Access Compliance Report

Public Rights-of-Way

Intersection ID: 10039814	Main Street: TOM_SHORT_RD	Cross Street: N/A	Location: SW
ADA ID: 35F33664B3E8	Ramp Type: PerpDiag	Initial Pass/Fail: Pass	Overall Compliance: No
			Severity Score: 12.75

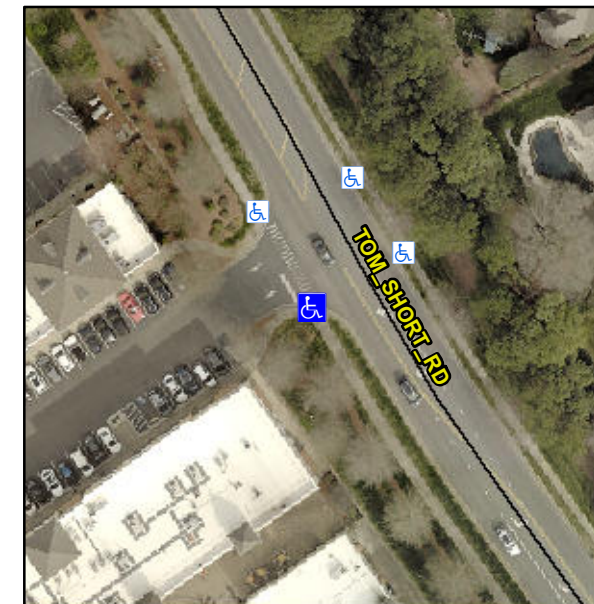
Not Found, R304.5.3, R304.2.1, R304.2.2-Perp, R304.3.2-Para, R305.1.4, R305.2

Compliance	Description	Data	Compliance	Description	Data
N/A	Ramp Length (in)	64.0	Yes	Ramp Slope (%)	6.4
Yes	Ramp Width (in)	49.0	No	Ramp XSlope (%)	3.0
N/A	Flare Type LT	Sloped	N/A	Flare Type RT	N/A
N/A	Flare Slope LT (%)	6.7	Yes	Flare Slope RT (%)	3.1
N/A	Flare Traversable LT?	Yes	N/A	Flare Traversable RT?	Yes
No	Landing Length (in)	N/A	Yes	DWS Provided?	Yes
No	Landing Width (in)	N/A	Yes	DWS Contrast?	Yes
No	Landing Slope (%)	N/A	Yes	DWS Length (in)	24.0
No	Landing X Slope (%)	N/A	No	DWS Full Width?	No
N/A	Landing Curb? (Y/N)	No	No	DWS Offset (in)	3.0
N/A	Shared Landing?	N/A			
Yes	Gutter Ponding?	No	Yes	Gutter Slope (%)	1.0
Yes	Gutter Lip Ht (in)	0.0	No	Gutter X Slope (%)	2.9
N/A	Painted X Walk1?	No	N/A	Painted X Walk2?	Yes
	X Walk 1 Direction	To NE		X Walk 2 Direction	To NW
N/A	X Walk 1 Width (in)	N/A	N/A	X Walk 2 Width (in)	61.0
	X Walk 1 Slope (%)	3.1		X Walk 2 Slope (%)	0.8
	X Walk 1 X Slope (%)	1.6		X Walk 2 X Slope (%)	5.0

Remove & Replace Curb Ramp With Two New Directional Ramps or Equivalent. Remove & Replace Gutter.
